# Access Compliance Report

## Public Rights-of-Way

### (Curb Ramps)

Intersection ID: 53147	Main Street: ACHIEVEMENT_LN	Cross Street: NEW_RENAISSANCE_WY	Location: NE
ADA ID: 980C40A2600D	Ramp Type: Perp	Initial Pass/Fail: Fail	Overall Compliance: No
Severity Score: 12.5			
Codes/Mitigation Info/Possible Solution		Field Measurements/Component Compliance

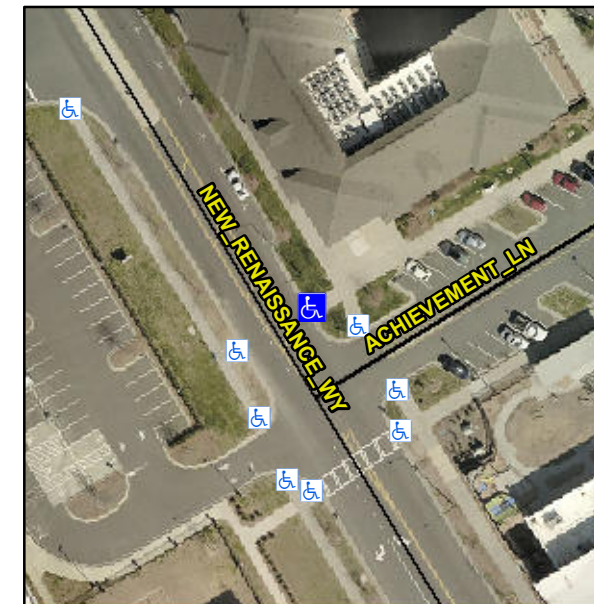
**R304.2.2**

Compliance	Description	Data	Compliance	Description	Data
N/A	Ramp Length (in)	96.0	No	Ramp Slope (%)	9.6
Yes	Ramp Width (in)	95.0	Yes	Ramp XSlope (%)	1.4
N/A	Flare Type LT	N/A	N/A	Flare Type RT	N/A
N/A	Flare Slope LT (%)	N/A	N/A	Flare Slope RT (%)	N/A
N/A	Flare Traversable LT?	N/A	N/A	Flare Traversable RT?	N/A
N/A	Landing Length (in)	N/A	N/A	DWS Provided?	N/A
N/A	Landing Width (in)	N/A	N/A	DWS Contrast?	N/A
N/A	Landing Slope (%)	N/A	N/A	DWS Length (in)	N/A
N/A	Landing X Slope (%)	N/A	N/A	DWS Full Width?	N/A
N/A	Landing Curb? (Y/N)	N/A	N/A	DWS Offset (in)	N/A
N/A	Shared Landing?	N/A			
N/A	Gutter Ponding?	N/A	N/A	Gutter Slope (%)	N/A
N/A	Gutter Lip Ht (in)	N/A	N/A	Gutter X Slope (%)	N/A
N/A	Painted X Walk1?	No	N/A	Painted X Walk2?	N/A
	X Walk 1 Direction	To SW		X Walk 2 Direction	N/A
N/A	X Walk 1 Width (in)	N/A	N/A	X Walk 2 Width (in)	N/A
	X Walk 1 Slope (%)	2.2		X Walk 2 Slope (%)	N/A
	X Walk 1 X Slope (%)	1.6		X Walk 2 X Slope (%)	N/A

**Remove & Replace Entire Ramp.**
